Interactive comment on “Water droplet calibration of a cloud droplet probe and in-flight performance in liquid, ice and mixed-phase clouds during ARCPAC” by S. Lance et al.

S. Lance et al.

Received and published: 23 October 2010

Fig. 1. (S1) Calibrated sizer (left) and qualifier (right) signals as a function of position within SAQ for 22 μm (top) and 12 μm (bottom) droplets.

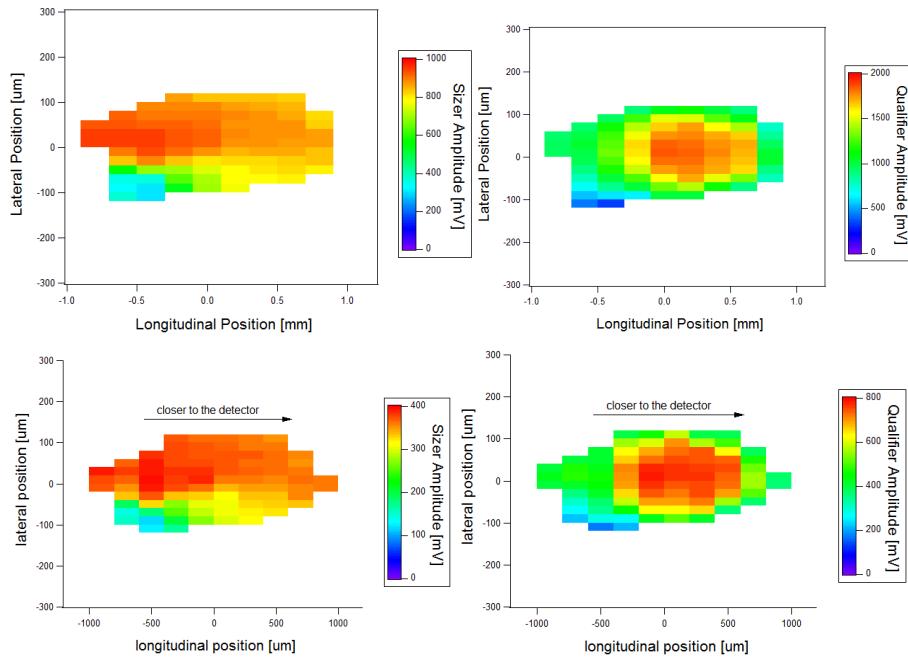
"I don't like the "brute-force" shift of the instrument response by 2um. As you state yourself, the undersizing occurs because droplets don't just pass through the maximum intensity section of the laser beam but also through regions latitudinally and longitudinally away from the center. The fact that Nagel et al. (2007) did a calibration only for the maximum intensity of the laser beam shouldn't keep you back from calibrating the probe all across SAQ. You already did that in Figure 3 and 4 (i.e., you

measured 22 and 12 micron droplets at various locations). Why didn't you use these all-SAQ measurements to perform a calibration that takes the intensity distribution into account? Strictly speaking, you should hardly ever measure the "greatest CDP sizing response" (p3134,I6) in real-world measurements since droplets cross the laser beam everywhere and the signal will always be below the possible maximum."

We now include in Figure 2 of the paper the sizer signal averaged over all positions within SAQ (Figure S5), obtained from the calibrations reported in Figure S1 (for 12 and 22 um droplets, respectively). The average response agrees well with the response reported for droplets at the center of the DoF. Again, this contradicts the statements above that we are now retracting from the paper.

Fig. 3. (S3) Simulated CDP response assuming various degrees of misalignment (see text for full caption)

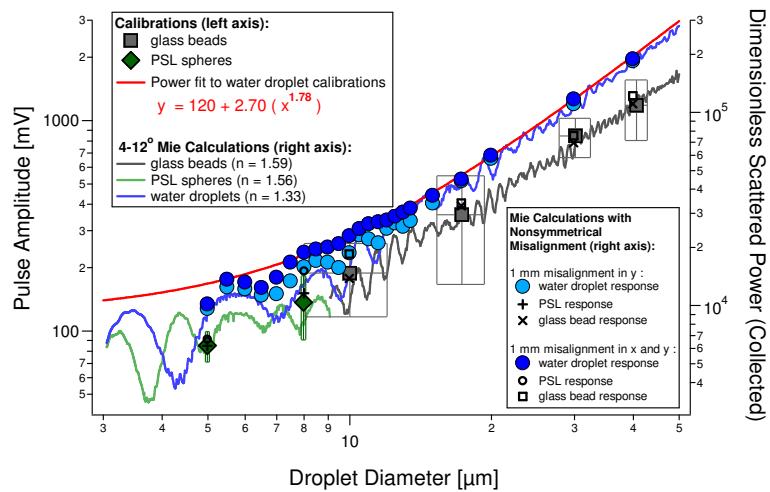
"Looking again at Figure 7: Your SAQ contour (small area) encompasses normalized sizer amplitudes ranging from about 0.85...0.95 (if my eyes are properly calibrated). Unfortunately, the SAQ is *not* centered around the maximum intensity of the laser beam within the lateral and longitudinal extent. The red areas (amplitude=1) are a few pixels left. If you aligned the droplet stream such that it maximizes the signal on the oscillator, you were about 0.2 cm away from the center of SAQ. If you had centered your droplet stream in the center of the SAQ instead, you would have had smaller signal amplitudes. Can you discuss the consequences of the mismatch between center of SAQ and maximum intensity of the laser beam on the calibration? Perhaps that's the explanation for the mis-sizing right there."

We now offer a new hypothesis for the discrepancy between the modeled and calibrated instrument response for water droplets. We speculate that the optical model is insufficient for this particular instrument due to optical misalignment (beyond the symmetrical ± 0.5 degree shift modeled). If the qualified sample area is out of alignment with the center of the laser beam, this would result in a different range of collection angles for qualified droplets than the 4-12 degree specification. Incomplete blocking of the primary forward scattering lobe can result in a dampening of the Mie resonance structure (if the misalignment is nonsymmetrical) and also an increase in scattered intensity (Figure S3). The result of this type of misalignment was determined by integrating the Mie solution over different collection geometries. A lateral displacement of ~ 1 mm for the qualified sample area relative to the center of the laser beam, results in a change in collection geometry for qualified droplets as depicted in Figure S4. We now add a paragraph in the paper describing the simulated effect of this type of non-

Figure S3 Caption: The calibrated response of the CDP to PSL and glass beads, and the calculated response for PSL, glass beads and water droplets assuming that all forward scattered light 4-12 degrees is collected by the sizing detector. The light blue dots show the modeled CDP response for water droplets given a 1 mm misalignment in the y-dimension (laterally across the laser, and perpendicular to the droplet trajectories). The dark blue dots similarly show the modeled CDP response for water droplets given a slightly greater misalignment. The fit to the water droplet calibrations is shown for comparison. The CDP response to PSL and glass beads, given these misalignments, are also shown, and often agree well with the PSL and glass bead calibrations.

Fig. 6. (S6) Histograms of the volume mean diameter normalized to d_{true} , for 22 μm (left) and 12 μm (right) water droplets distributed throughout SAQ

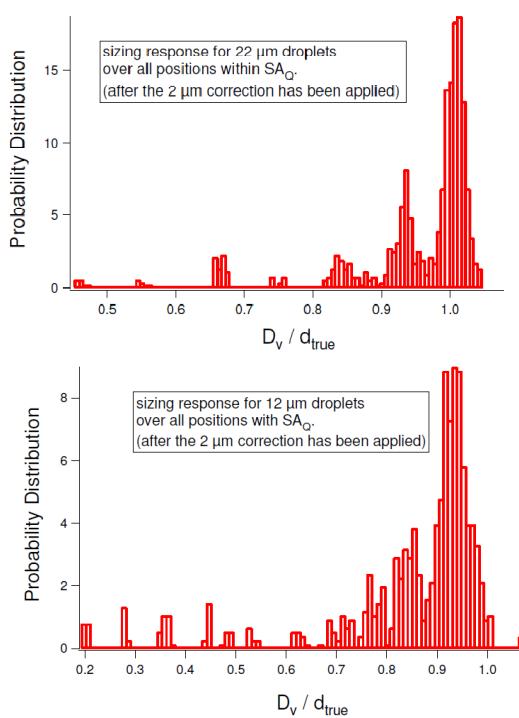
"I would encourage you to make the following additional plot after Figure 4: Within SAQ, plot a histogram of D_v/D_{true} . Make sure you identify the pixel where you originally did the calibration. At this pixel, D_v/D_{true} should be equal to 1. However, following Figure 7, I am not even sure that the maximum intensity lies within SAQ!"

We provide a histogram of $D_v/dtrue$ values within SAQ for the reviewer (Figure S6). However, we find that a histogram of sizer pulse amplitudes within SAQ is more instructive, because this is actually what was used in the simulations to constrain the instrument response for droplets randomly transiting across SAQ (Figure S7). Since

D_v is a binned value, with resolution on the order of 10-20% of the droplet size, the histogram of $D_v/dtrue$ has multiple local maxima, whereas the histogram of pulse amplitudes has a more Gaussian shape (although truncated at larger pulse amplitudes due to misalignment between the qualifier mask and the center of the sizing detector).

Fig. 7. (S7) Histograms of sizer pulse amplitudes for 22 μm (left) and 12 μm (right) water droplets distributed throughout SAQ.

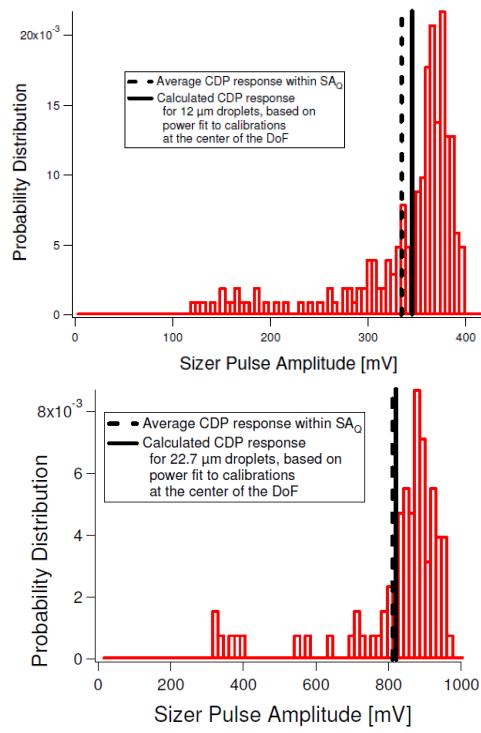
"Page 3150 (line 23-26) is slightly confusing. You say that undersizing of 74% and oversizing of 25% may occur within SAQ, but in the same sentence you say that the "most likely" bias is -1.2% (-8.6% on average). The "most likely" vs. "average" vs. "maximum" (-74%...+25%) would be far better illustrated by adding the aforementioned additional figure. Also, how does that relate to the bias shown in Figures 2 and 3? Is Figure 4 based on the CDP response that was shifted by 2 microns? The fact that the "maximum" bias is +25% suggests that indeed it was already shifted - why else should you get a *larger* size across the sampling volume if you already positioned your calibration droplets at the intensity maximum!"

We agree that the textual description is confusing, and the best way to relay this information is with a histogram. You are correct that the 2um shift had already been applied for the $D_v/dtrue$ results, and we say this explicitly now in the paper.

Again, however, we believe that showing a histogram of sizer pulse amplitudes (Figure S7), rather than a histogram of $D_v/dtrue$, more clearly communicates the instrument response. We add to this histogram the response for equivalently sized droplets transiting through the center of the DoF (using the power fit to the water droplet calibrations from Figure 2 of the paper). By doing this, one can directly compare the response at the center of the DoF (from which the 2um offset was obtained) to the average response
